Environmental Review Team
Report
on

Fox Ridge Estates
Tolland, Connecticut

July 1979

The Eastern Connecticut Environmental Review Team was asked to review a subdivision proposal for a 60± acre parcel in the town of Tolland, owned by Joseph Mihaliak, a Stafford resident. This development, to be known as Fox Ridge Estates, is located in southeastern Tolland on South River Road and extends east to the Willimantic River. Preliminary plans have been prepared by Stanley Szeztowicki, R.L.S. Engineering for interior roadways has been developed by Lenard Engineering of Storrs.

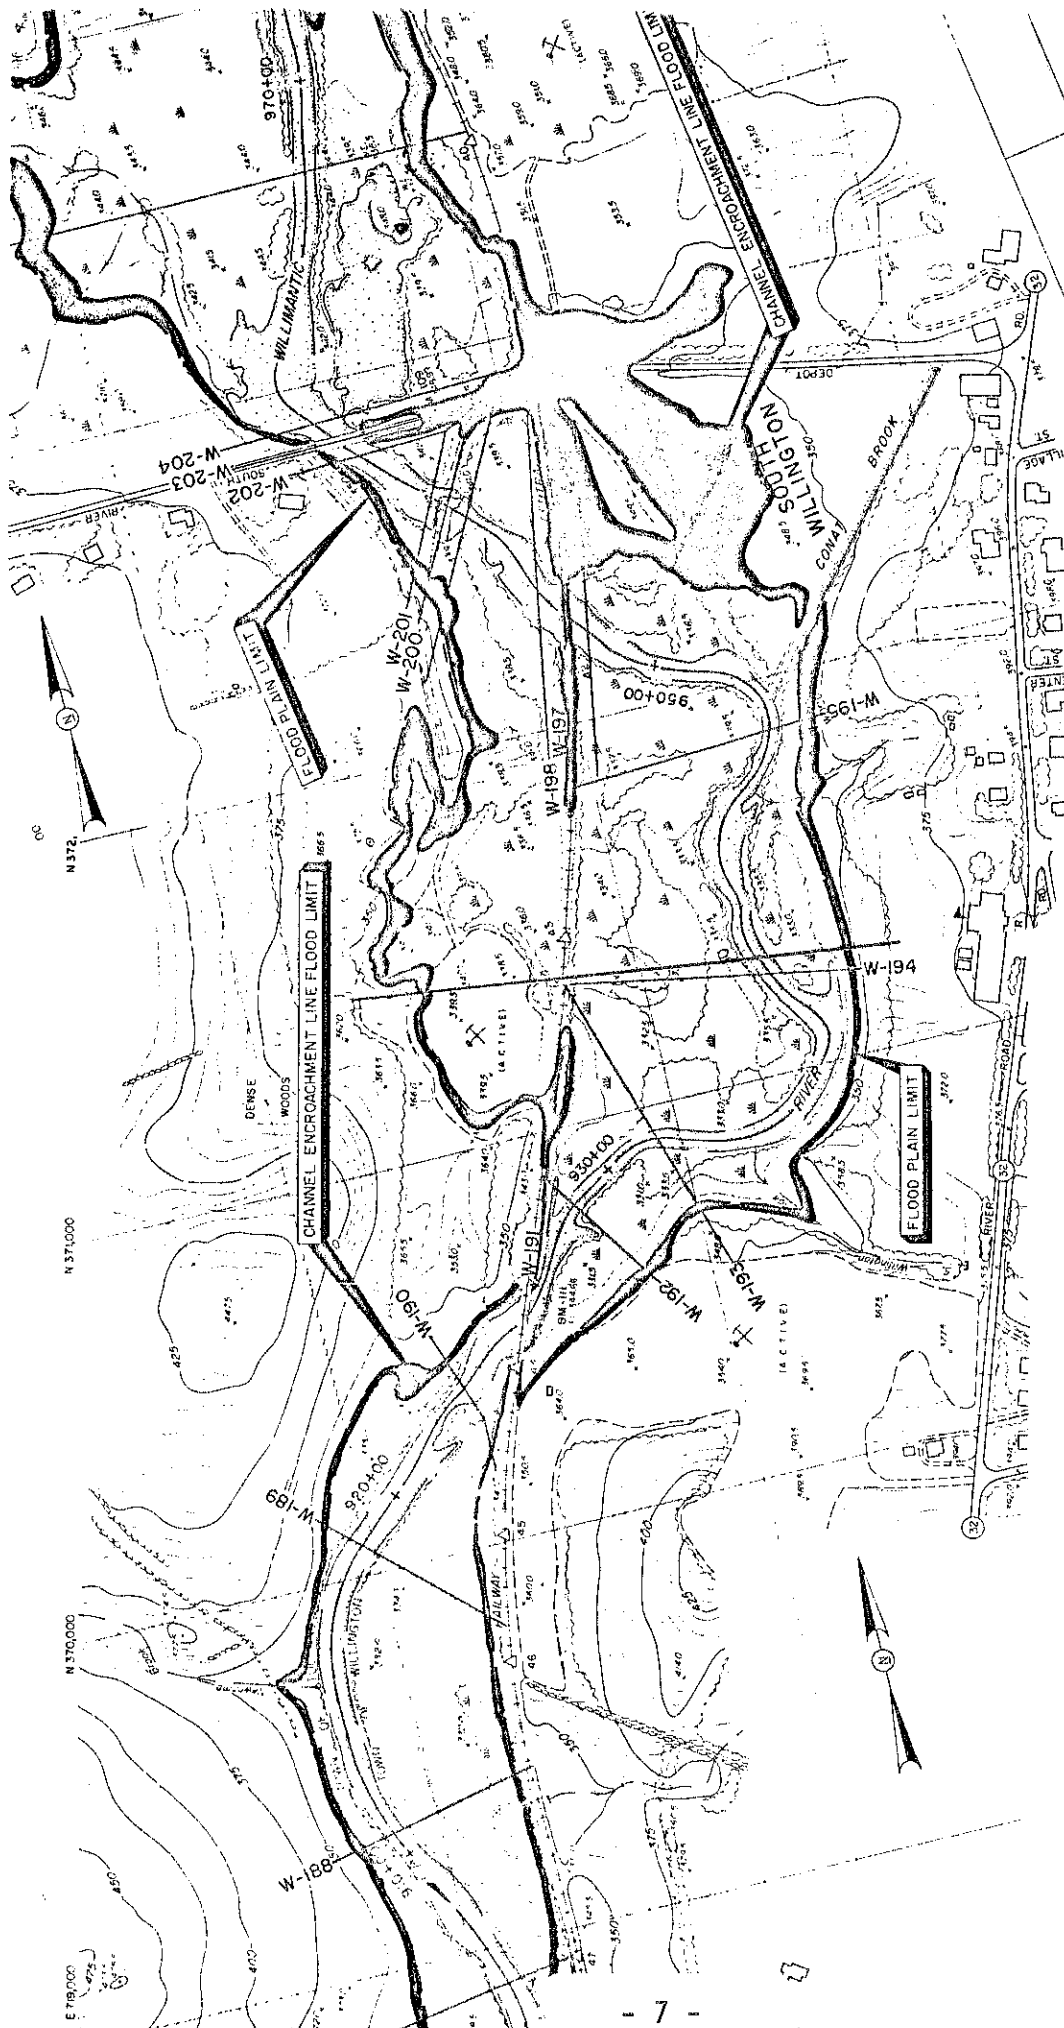
Hence, the floodplain acts as a type of natural basin during high flow periods, with water being temporarily stored in the floodplain.

A report prepared in 1971 for the State of Connecticut Water Resources Commission recommended the establishment of flood encroachment lines along Willimantic River, including that stretch bordering the site (see accompanying illustration). In theory, the prevention of development within the encroachment area would assure a reasonable channel for the passage of the 100-year-frequency flood. Floods of greater magnitude are possible, also; such floods would affect additional areas outside of the designated encroachment lines, but the probability of their occurrence in a given year would be less than one percent.

It is possible that the gravel excavation has lowered the surface elevation of some parts of the site within or bordering the encroachment area. This could mean that the design flow (that flow rate used to calculate the location of the encroachment lines) would presently be accommodated in either a greater or lesser area than that delineated in the accompanying illustration. For instance, excavation within the encroachment area, by increasing the storage depth available, would decrease the surface area needed; on the other hand, excavation on land bordering the encroachment area could allow the flood flow to spread further within the site. In order to assure protection of lots within the subdivision as well as downstream locations, no filling should occur in the encroachment area designated in the 1971 report. However, filling should be sufficient to allow houses, driveways, and other structures to be higher than the flood elevations given in the 1971 report. Paul Biscuti, an engineer with the Water Resources division of the Department of Environmental Protection, has reviewed the proposed subdivision plans and believes that they allow sufficient protection of both the subdivision and downstream areas.

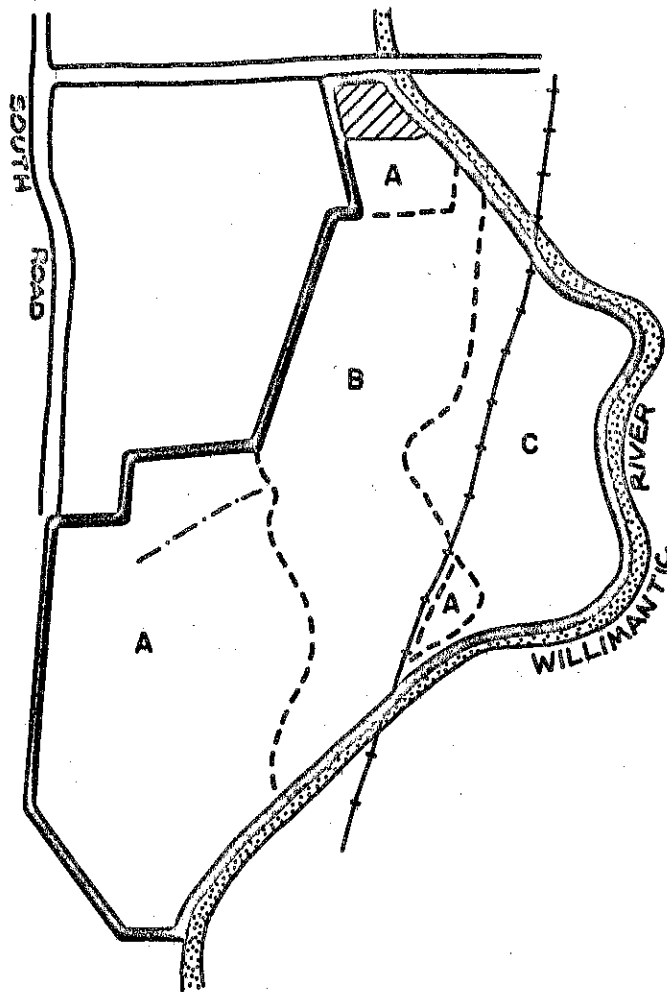
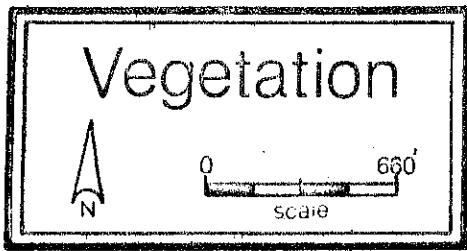
Development of the site will increase the amount of runoff during periods of precipitation. The areas of most concern are the steeper portions of lots 9-17 and lot 29, and the discharge point for the proposed cul-de-sac. In these areas, runoff may lead to erosion problems, such as gullying. Appropriate erosion-control plans should therefore be included with the final design.
